### ARMED FORCES RETIREMENT HOME

SUBJECT: EARLY CONSULTATION ON PROPOSED MASTER PLAN AMENDMENT

#### Exhibit 1: Revised Base Plan for Zone A

Figure 3.1 Street Edge Map for Zone A

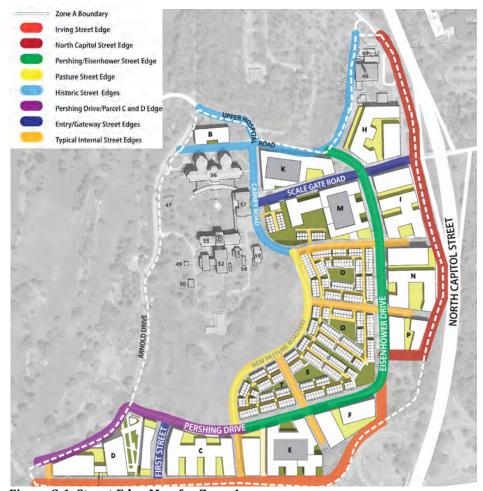
To further inform individual development proposals, Master Plan Amendment #2 presents revised built form guidelines that allow the general guidance to be applied in a more refined approach without being overly prescriptive. These guidelines provide design objectives and direction based on a categorization of street edges, which reflects visual context and hierarchy of the streets within Zone A. The map below illustrates the street edge categories defined in the amendment.

The following summarizes the specific design objectives for each street edge section.

Figure 4.1 Revised future adapatibility plan for Zone A

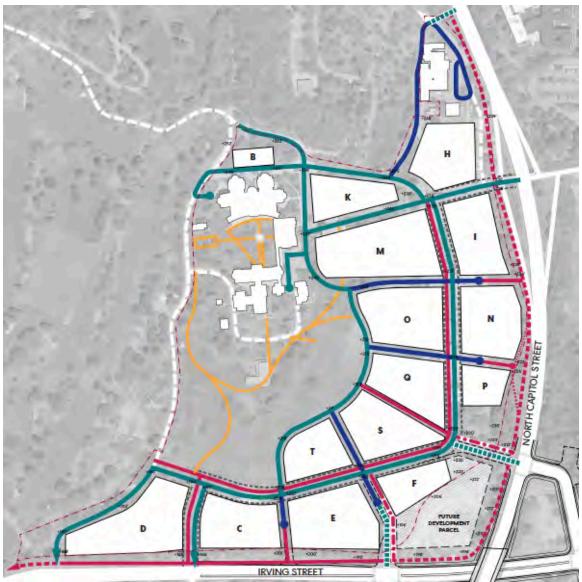
The following graphic is revised to show an updated plan for adapting the eastern perimeter of Zone A to a potential reconfiguration of the cloverleaf interchange at Irving Street and North Capitol Street and to a more urban street section along North Capitol Street.

Figure 5.1 Revised configuration of Parcel M.

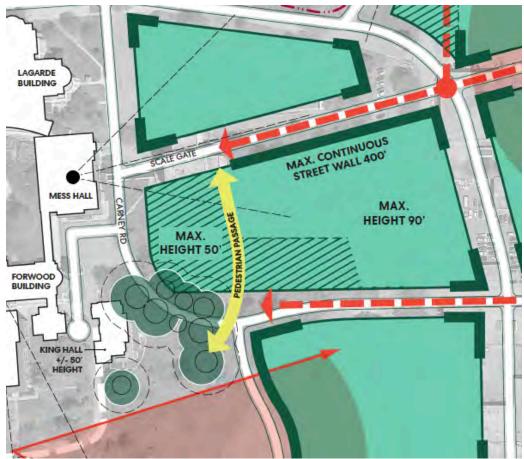
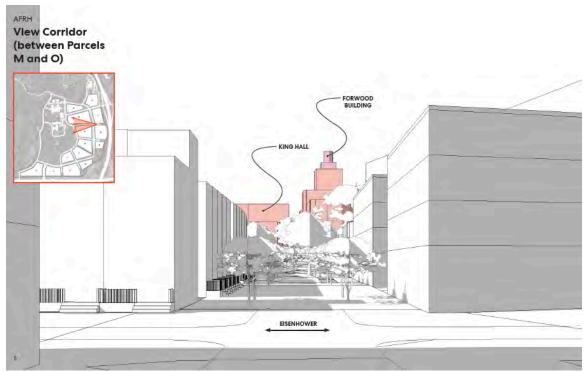
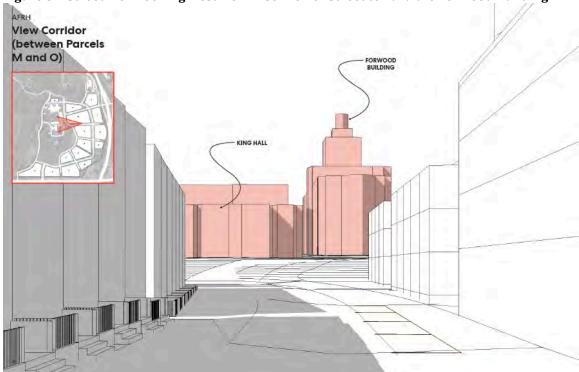
Master Plan Amendment #2 includes a reconfiguration of Parcel M to achieve the following planning objectives:

- Preserve existing mature trees by reusing the alignment of the existing road and reducing grading impacts;
- Create a more continuous and active connection between Scale Gate and the Historic Core;
- Provide a mix of densities, building types, and uses on this parcel; and
- Provide a more defined edge to the northern end of the Pasture.

Although the reconfiguration moves the new development closer to the historic core, location-specific design guidelines ensure that that new buildings are both deferential to and compatible with the historic buildings. These guidelines focus on architectural character, as well as setbacks both at the ground level and at upper levels of development to preserve important axial views to the historic Forwood Building and King Hall.

$\stackrel{\cdot}{\text{Figure 8.2 Revised street section for Pershing Drive to be included in Master Plan Amendment}}{\text{\#2}}$

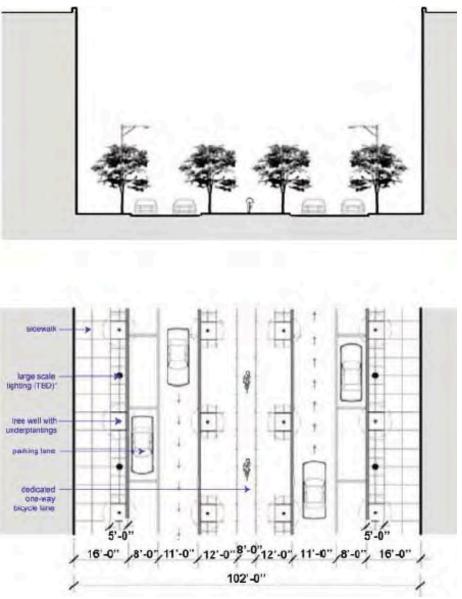
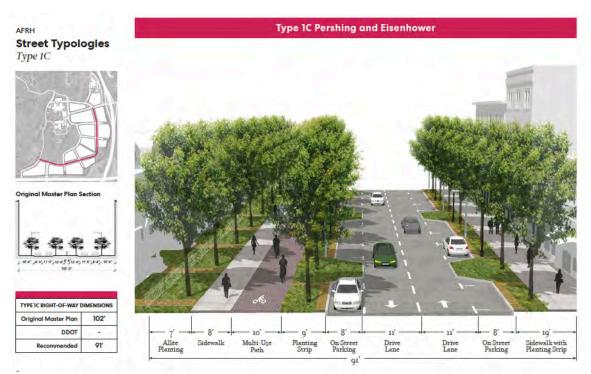
Historic Pershing Drive consists of a narrow unpaved road flanked by an allee of trees. The original Master Plan provides a street section for the new Pershing Drive with vehicular lanes that flank the historic resource, making the original road and tree allee a center median of the new road. Maser Plan Amendment #2 includes a revised street section that shifts the historic resource (road and tree allee) to the north side of the new road to create a more pedestrian- and bike-friendly street section. The historic resource now becomes a multi-modal trail and landscape buffer between the new vehicular road and the residential development to the north.
